127 1/2 Chicago St

Owner E. M. Lewis Theatres

Location 631 Congress St.

Electric Sign for E. I. L.  
CASCO THEATRE.

# LOU'S RATED THEATRE SIGN

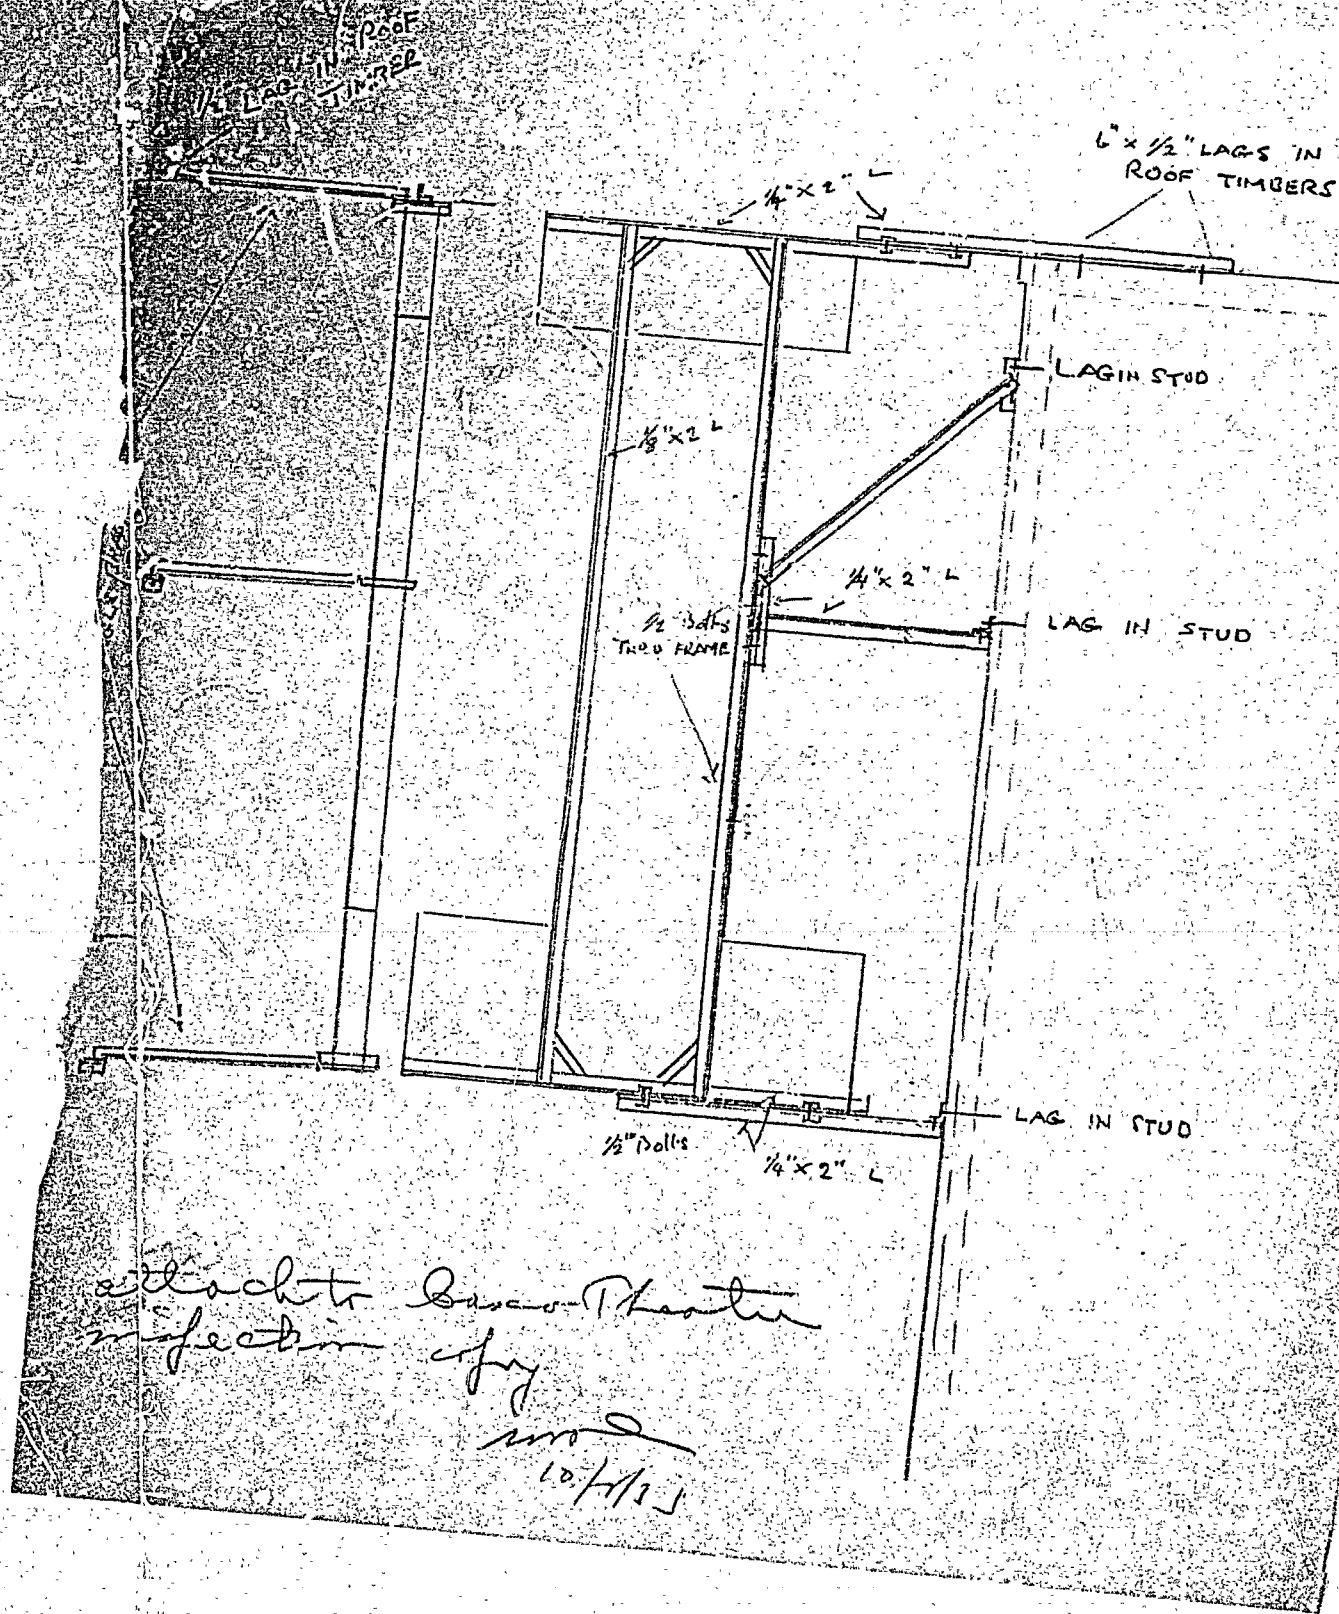
Plans for this sign had been made up on the basis that it would be newly constructed, but as the sign was an existing one and had been taken down from another of E.M. Loew's houses, the center leg shown on the plan was not put on.

With reference to the wooden moulding that the glass faces are set in, I do not believe same unsafe in any way, even though the regulations require the exclusive use of non-combustible materials. The wooden mouldings are protected at the back and at the side by sheet-metal and if a fire should start in the sign it would be entirely confined to the insulation of the wires.

Although shown on plan and omitted when sign was erected I find upon computation that the leg is not necessary and that the sign will be safe without it. Further the outside vertical iron in the sign has a swaybrace supporting it against lateral bending. Not regarding the presence of this brace and figuring the vertical irons as unsupported laterally from the top to the bottom of the sign, a length of 14'6", the following computations result:

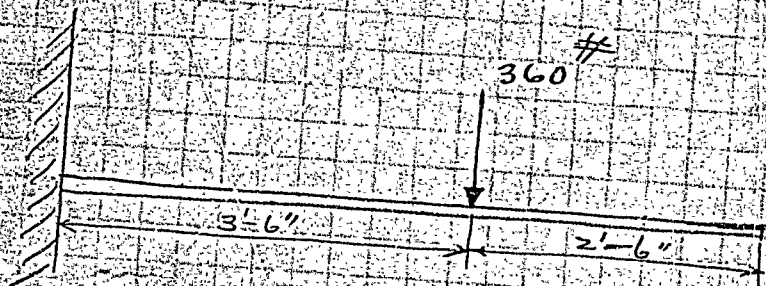
The plan with the application indicates that there are to be three 2x2x1/2 inch angles besides the gyps, one at the top, one at the middle, and one at the bottom. There are only two angles directly supporting the sign, one at the top and one at the bottom, and the one at the bottom is 1/8th inch thick instead of 1/2 inch thick. Furthermore the support at the bottom is broken up with two connections in a manner which is not structurally sound.

Under the circumstances, I believe it will be necessary to remove the sign completely from the building, altering it to satisfy the requirements and again erect it in a manner calculated to safely hold the sign in position, or also leave the sign down and forego the use of it.

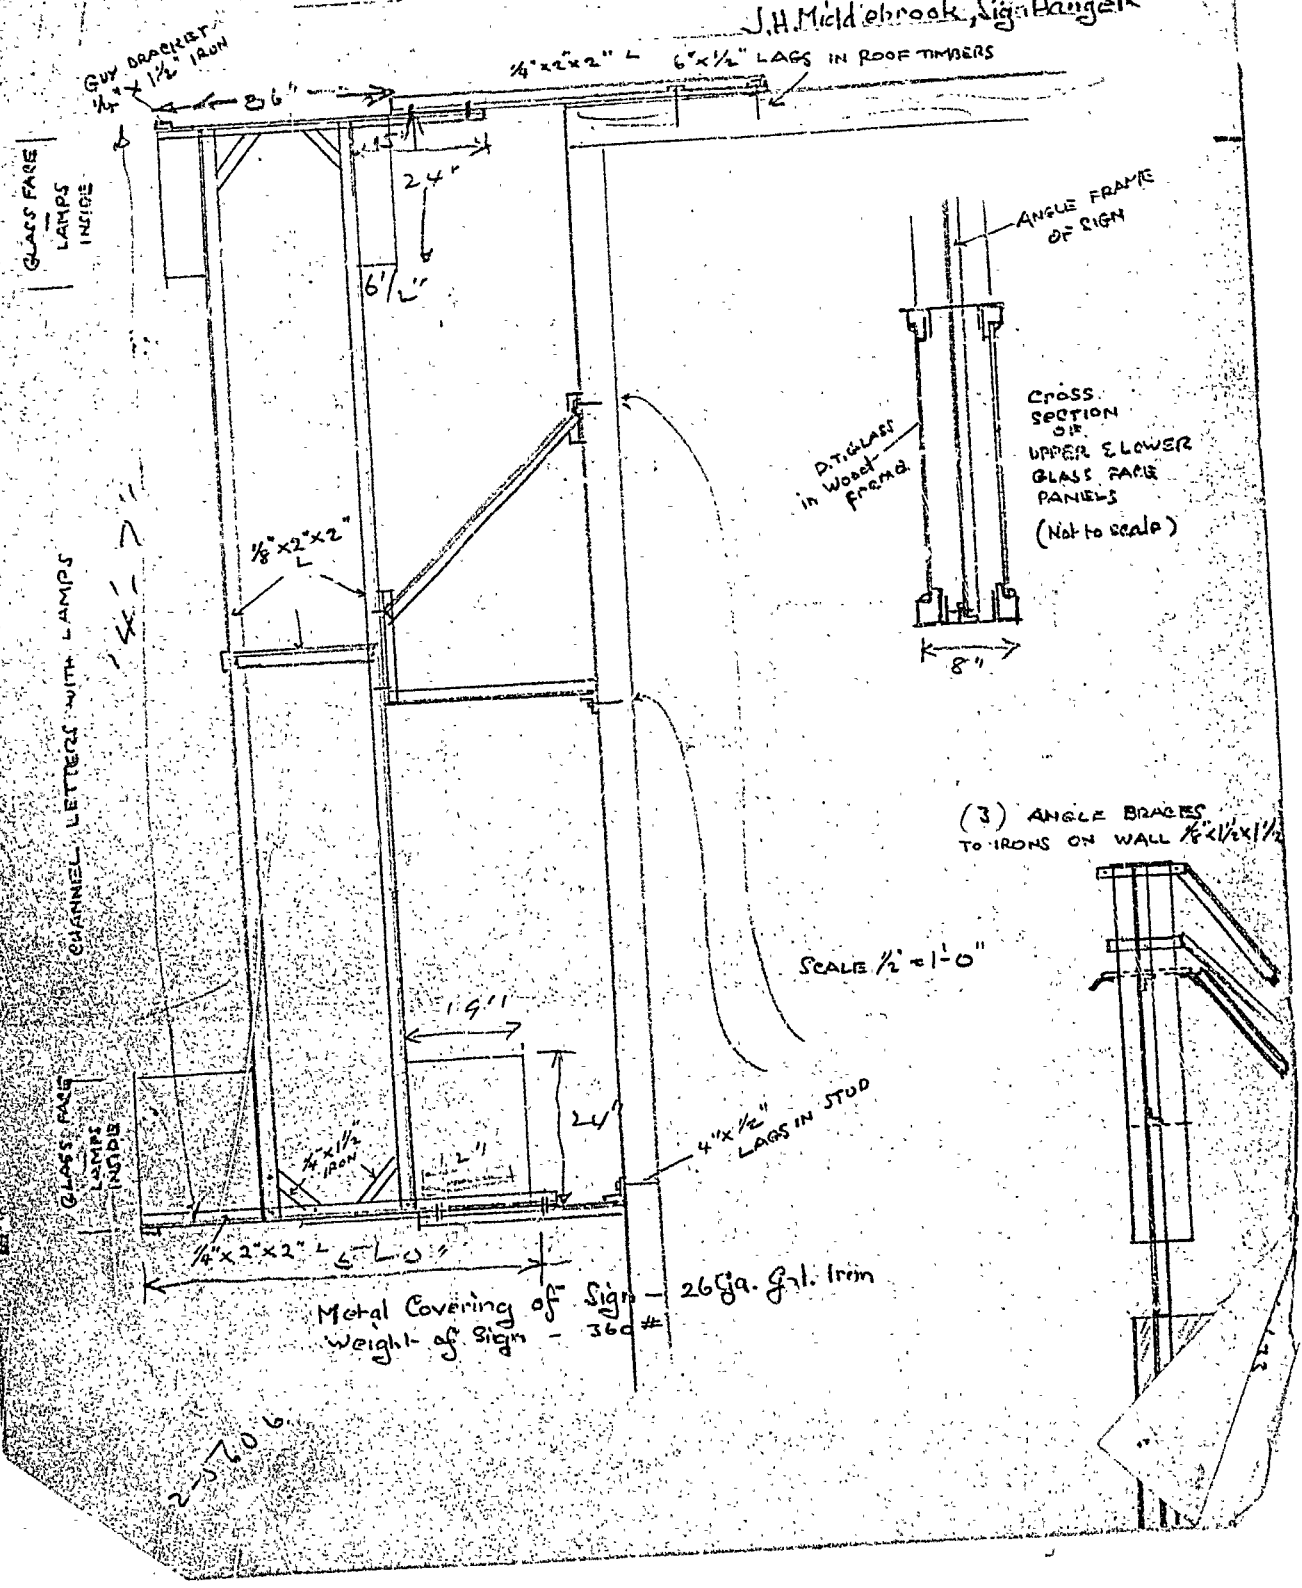
$$M = Wb = 360 \times 3.5 \times 12 = 15120 \text{ in lb}$$

$$\text{Required sect. mod.} = \frac{15120}{18000} = 0.84$$

$$\text{Sect. mod. of } 2 \frac{1}{2} \times 2 \frac{1}{2} \times \frac{1}{4} \text{ L} = 0.39$$

OK 3 L's used  $\Sigma = 1.17$
